Technical Evaluation Report Salem Generating Station Storm Surge Hazard Reevaluation Review

TECHNICAL EVALUATION REPORT

STORM SURGE

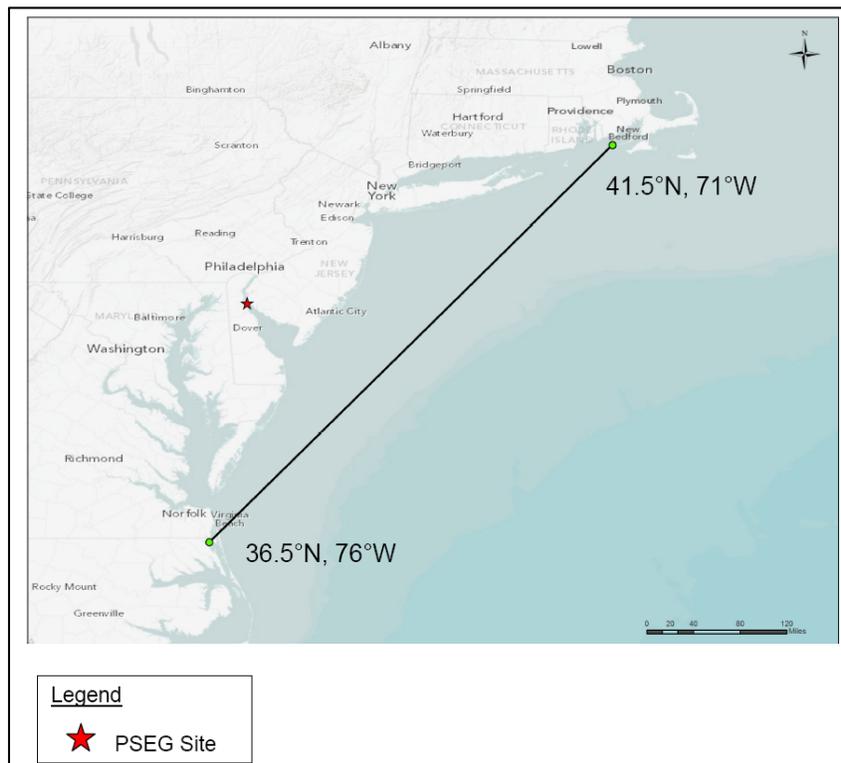
The storm list in Table 1 (FHRR Table 2.4-10) provides pertinent information for storms with headings towards the PSEG SGS site. The transect applied for the analysis (Figure 1, FHRR Figure 2.4-11) provides a reasonable capture area given the PSEG SGS site location. The capture area applied covers storms with various headings that could cause significant storm surge near the PSEG SGS site. The storms in Table 1 and Figure 1 provide the basis for the FHRR analysis.

Figure 2. Revised demarcation line for historical storm central pressure analysis (FHRR Figure RAI-5-2)

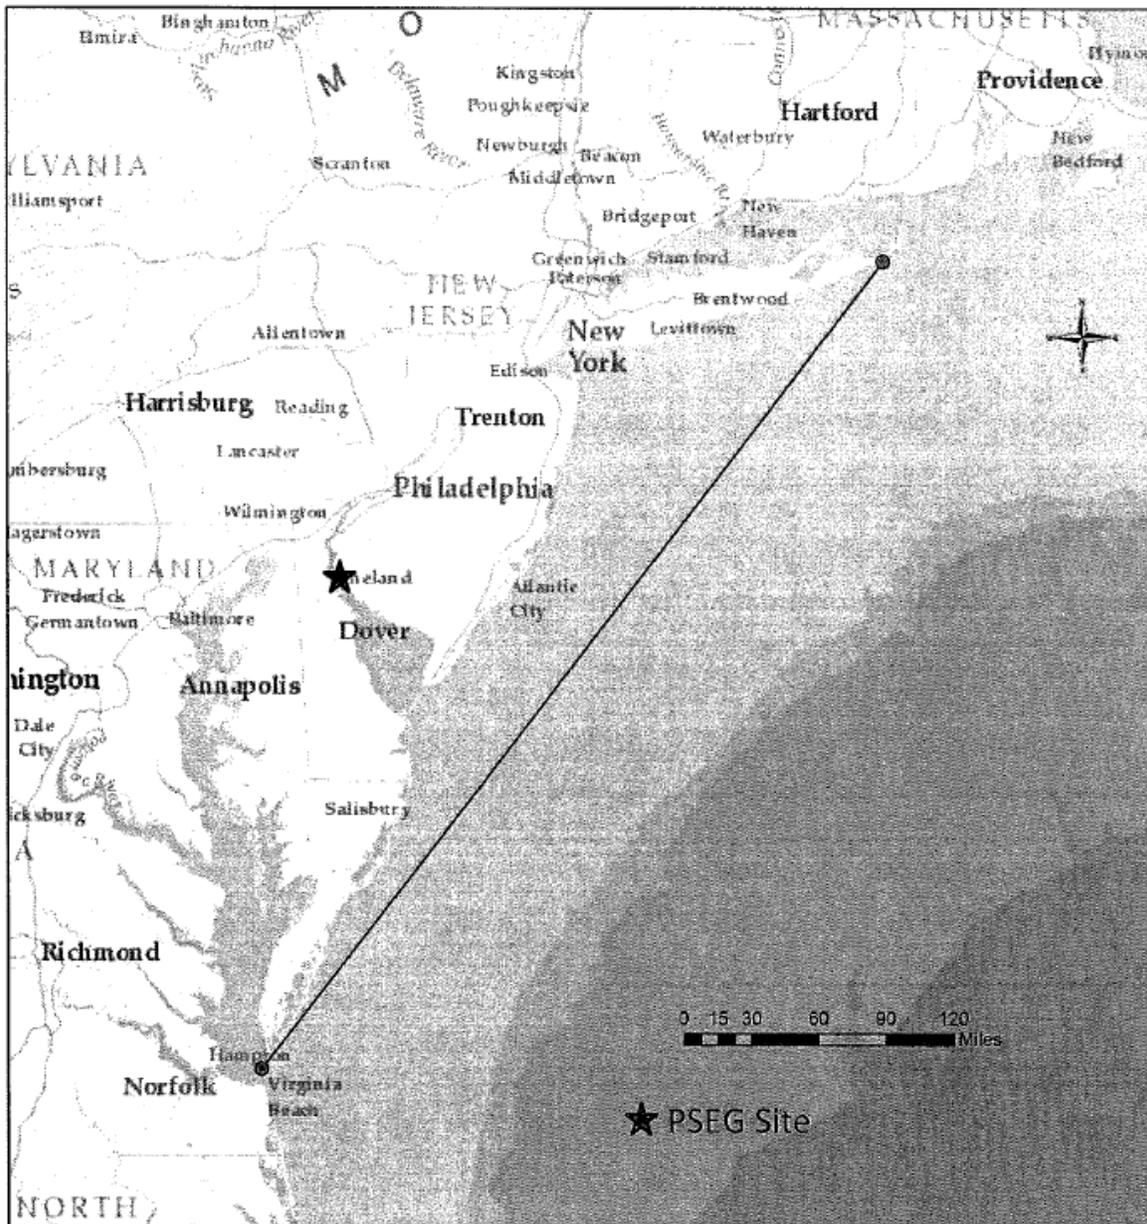
Within the response to RAI Question 5, PSEG provides the storm listing and demarcation line in Table 2 and Figure 2. As part of the response to RAI Question 5, PSEG completes a revised probabilistic-deterministic storm surge analysis based on the revised storm set and revisions to other analysis parameters. The response to RAI Question 5 states that revised analysis produces a lower 10^{-6} Annual Exceedance Probability (AEP) storm surge water elevation. Thus, the revised analysis indicates that modifications to the storm suite do not increase the estimated 10^{-6} AEP storm surge water elevation at the site.

Staff notes that hurricanes Carol (1954) and Connie (1955) were on the original FHRR storm list, but are not on the RAI response storm list. Hurricane Donna, was not on the FHRR storm list, but is on the RAI response storm list.

Figure 5. Comparison of FEMA Region III Mesh and PSEG FHRR Mesh near the PSEG SGS site

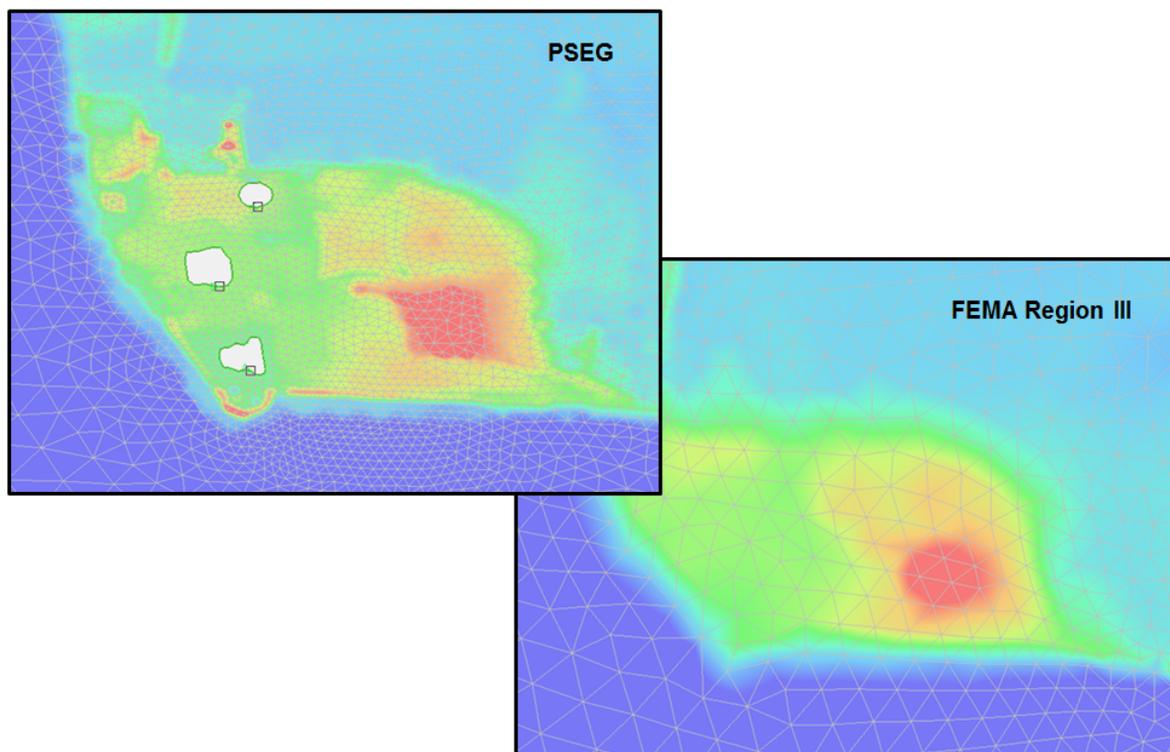
The FEMA Region III study had a regional scope and developed a mesh with resolution limits appropriate for the regional view. By adding resolution near the SGS site, the FHRR analysis improves the ADCIRC+SWAN models capability to resolve important local features. Review of the FHRR mesh features in the modified area and comparisons to the Region III mesh shows proper implementation of the increased mesh resolution. Figure 5 shows a comparison of the FEMA Region III mesh resolution and the PSEG FHRR mesh resolution near the PSEG SGS site. The figure shows the level of increased resolution near the PSEG SGS site and the increased level of detail in the topographic features allowed by the increased resolution.

Review of the PSEG FHRR ADCIRC+SWAN mesh shows the model provides a highly-resolved model grid that applies the FEMA Region III model mesh — built with the best-available bathymetry and topographic data.

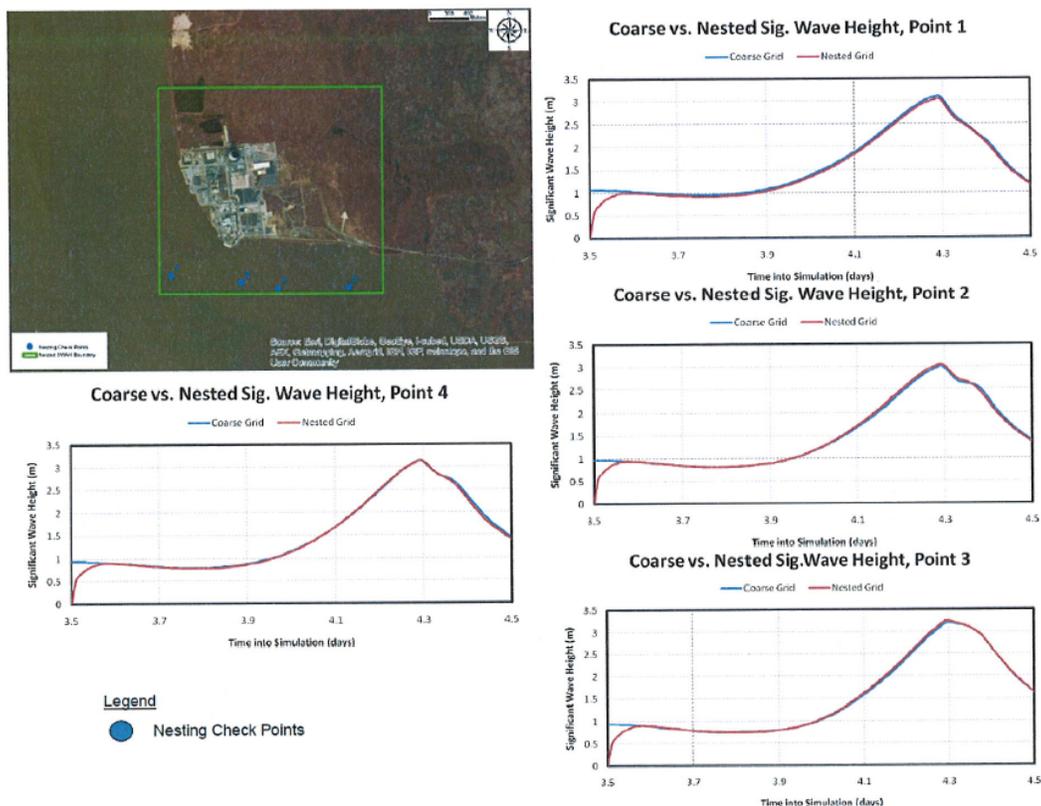
best-available bathymetry and topographic data. Revalidation of refined SWAN+ADCIRC mesh (Figure 8) and the nested SWAN model (Figure 7) demonstrates that changes to the FEMA Region III mesh do not alter model results away from the PSEG SGS site and allow for increased resolution of site-specific features.

The comparisons of the nested SWAN model results with the ADCIRC+SWAN model results in Figure 7 (FHRR Figure 2.4-13) shows the nested grid model produces results similar to the ADCIRC+SWAN model with the refined mesh near the PSEG SGS site. The FHRR report does not provide any direct comparisons of ADCIRC+SWAN model results versus measured data. Review of USACE (2013) shows comparisons of ADCIRC+SWAN model results versus measured wave data for Hurricane Isabel, Hurricane Ernesto, and Extra-tropical Storm Ida (Nor-Ida). The USACE (2013) report states that, despite a significant effort to locate data, only limited wave parameter validation data exist for the three storms. The USACE (2013) comparisons of measured and modeled significant wave height, peak wave period, and mean wave direction show good agreement.

Figure 9. Comparison of PSEG ESP application and NRC independent PMH simulations at western edge of the ESP site

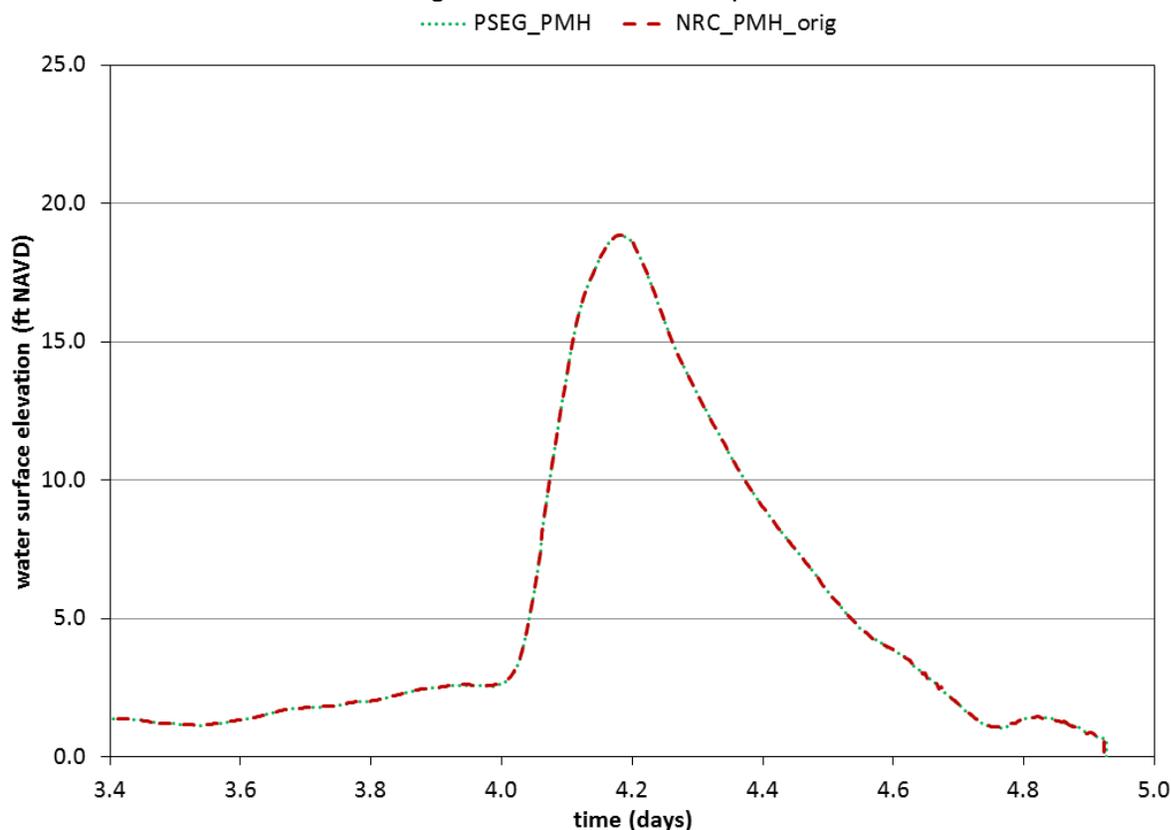
These parameter ranges match those applied in the PSEG ESP application. The PSEG ESP application PMH storm applies NWS 23 value for p_0 , Δp , and track direction along with the largest R value (28 nmi (51.9 km)) and slowest forward speed (26 kts (48.2 km/hr)). Importantly, the PSEG PMH simulations applied a landfall location offset 28 nmi (51.9 km) southwest from the center of the Delaware Bay mouth (PSEG ESP SSAR Figure 2.4.5-1). These parameter values provide the input forcing the PSEG ESP application PMH storm — results replicated in an NRC independent ADCIRC+SWAN simulation (Figure 9). At the PSEG SGS site, the PSEG ESP application and NRC staff independent PMH simulations produced maximum still WSEL near 18.6 ft-NAVD88 not including the tide, SLR, or runup.

Figure 10. PSEG ADCIRC+SWAN mesh with elevation contours (m) and location of land boundary string.

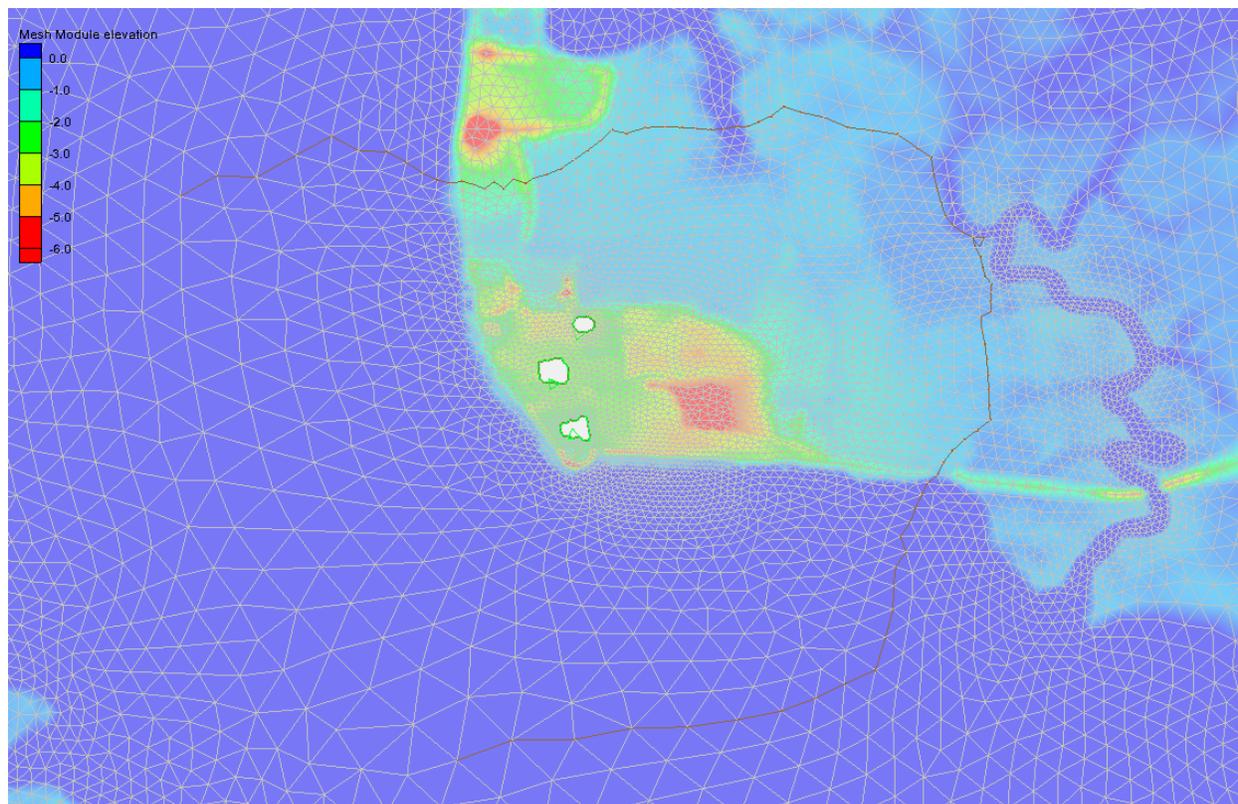
Detailed review of the ADCIRC+SWAN model PMH simulation results in the immediate vicinity of the PSEG SGS site revealed some notable maximum water level features that NRC staff considered in need of further investigation. The features presented as undulations in the maximum WSEL with the undulation magnitude on the order of a few feet. Review of the model mesh input file revealed a line of 92 land boundary nodes shaped in an arc that surrounded the north, east, and south side of the PSEG SGS site and extended into Delaware Bay (Figure 10). Staff did not find documentation for the rationale of including this feature in the model mesh. To evaluate the sensitivity of the maximum WSEL results near the PSEG SGS site to the node string, NRC staff removed the node string and executed an ADCIRC+SWAN simulation with the PMH storm forcing. The ADCIRC+SWAN model results for the simulation with the land boundary nodes removed show similar water level features as compared to the original PMH simulation. Detailed review of the WSEL in contour plots shows no WSEL undulations in the vicinity of where the land boundary nodes were located in the original simulation. The differences in maximum WSEL near the PSEG SGS site range from approximately +/- 0.1 ft (0.03 m) for the with land boundary versus without land boundary simulations. At times other than at maximum WSEL, differences can exceed 0.3 ft (0.91 m). These results indicate that the

land boundary nodes, while not having a documented purpose, cause only a minor effect on the maximum water level values near the project.

Figure 11. NRC staff confirmatory ADCIRC+SWAN model WSEL time series compared with the licensee results at the west side of the SGS site

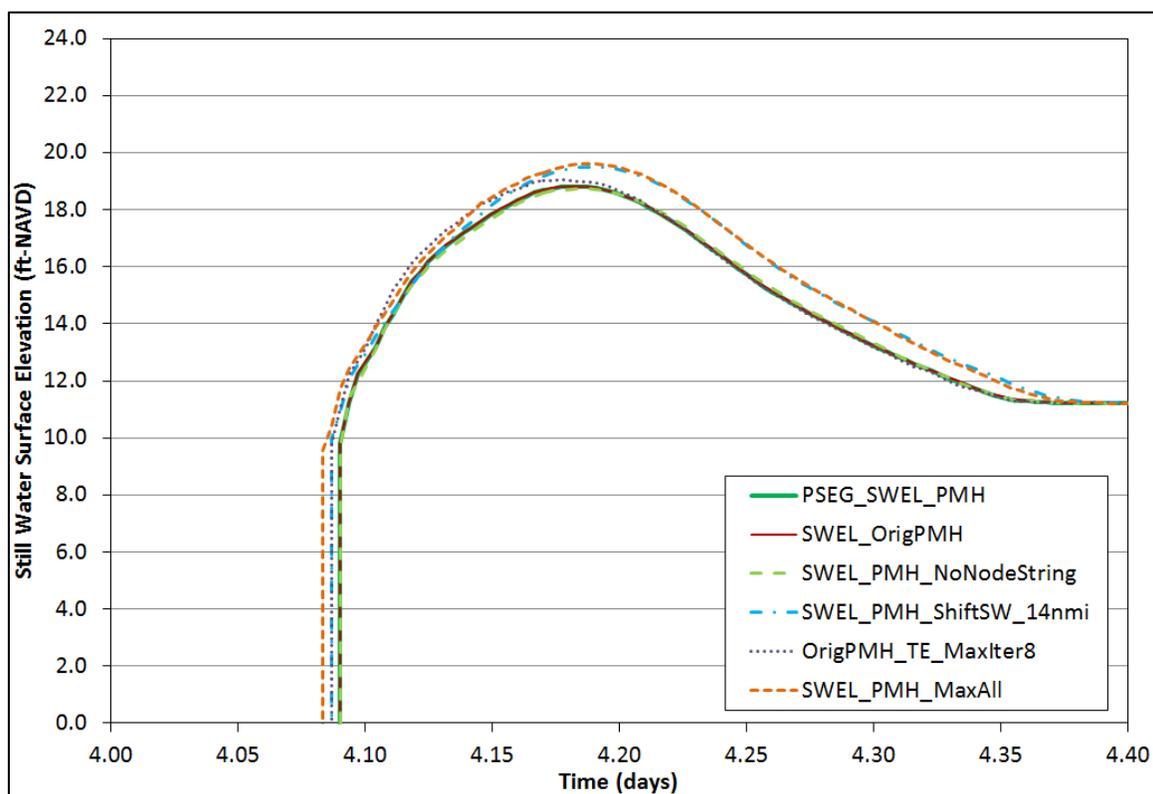
Figure 11 compares still WSEL time series for several PMH simulations at the west side of the SGS site. The plot includes the results of the PSEG PMH simulation and independent PMH simulation conducted by the NRC staff; the simulations show almost identical results. Figure 11 also contains additional sensitivity model simulations. Removing the land boundary node string from the PSEG ESP application mesh does not significantly alter the simulated water levels at the site. Shifting the PMH storm track approximately 14 nmi (25.9 km) to the southwest increases the maximum water level at the site by about 0.7 ft (0.21 m). Increasing the number the maximum number of iterations to 8 in the SWAN model didn't significantly change the water levels at the site. The final confirmatory simulation (MaxAll) shifted the landfall location 14 nmi (25.9 km) to the southwest, removed the land boundary arc, and set the SWAN MAXITNS parameter equal to 8. This simulation shows slightly higher maximum water levels than the simulation with the storm track shifted 14 mi (25.9 km) southwest.

Figure 12. NRC staff confirmatory ADCIRC+SWAN model significant wave height time series compared with the licensee results at the west side of the SGS site

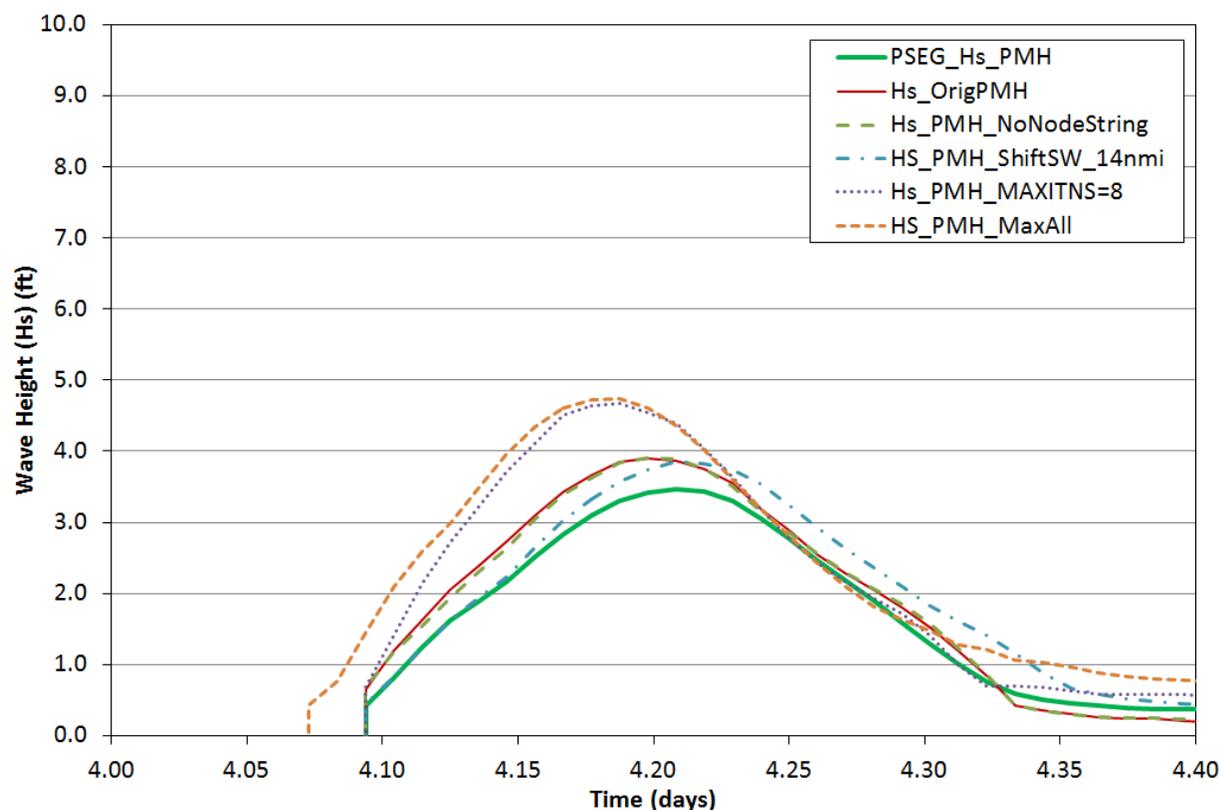
As previously mentioned, the PSEG FHRR models included a nested SWAN model that should further refine the wave results near the PSEG SGS site. The independent NRC staff simulations did not apply a nested SWAN grid. Comparison of significant wave height (Hs) time series at locations near the PSEG SGS site show similar wave heights and mean periods for the PSEG ESP application PMH and NRC staff PMH simulations for most comparisons. The NRC staff's PMH simulation with unexplained land boundary nodes removed produces slightly larger wave heights at some locations near the PSEG SGS site (locations adjacent the land boundary). The Hs results for the simulation with the land boundary nodes removed reach approximately 0.5 ft (0.15 m) to 1 ft (0.31 m) higher than the PSEG PMH simulation results. For locations closer the PSEG SGS site in areas that feature depth limited waves, the difference in Hs is negligible. Because the larger differences in Hs do not exceed one ft and locations nearer the PSEG SGS

site show negligible difference, the effect of the land boundary should not cause significant effects on water levels or wave runoff.

NRC staff also executed additional simulations designed to understand the influence of changing the maximum number of SWAN iterations (MXITNS = 2) on wave height within the spectral wave model solution. Recent coastal surge studies have applied different values for the MXITNS parameter, with a value of two representing the low end of the range. NRC staff executed ADCIRC+SWAN simulations with MXITNS = 8 and MXITNS = 12 to evaluate the sensitivity of the ADCIRC+SWAN model result to the parameter selection. The results of the MXITNS = 8 and MXITNS = 12 simulations show similar wave height and period values near the PSEG SGS site with values that exceed those of the MXITNS = 2 simulation (original ESP application PMH simulation). At the west side of the PSEG SGS site (location with largest SWAN waves), the higher MXITNS simulations have maximum significant wave heights equal to 8.3 ft (2.53 m) versus 6.7 ft (2.04 m) for the MXITNS = 2 simulation. For locations further from the site, but still in close proximity — labeled “perimeter” locations in the PSEG input files — the higher MXITNS simulations have maximum significant wave heights from 1 ft (0.31 m) to 4.5 ft (1.37 m) larger than for similar locations in the PSEG MXITNS = 2 simulation. Review of mean wave periods near the site shows the higher iteration threshold generally reduces the simulation mean wave periods (Tmo1) on the order of 1 to 2 seconds. Importantly, the results for the increased MXITNS values alter the timing of the maximum wave heights, but do not change the timing of the maximum water levels (Figure 11). Timing of waves and water level is important for the wave runoff calculations.
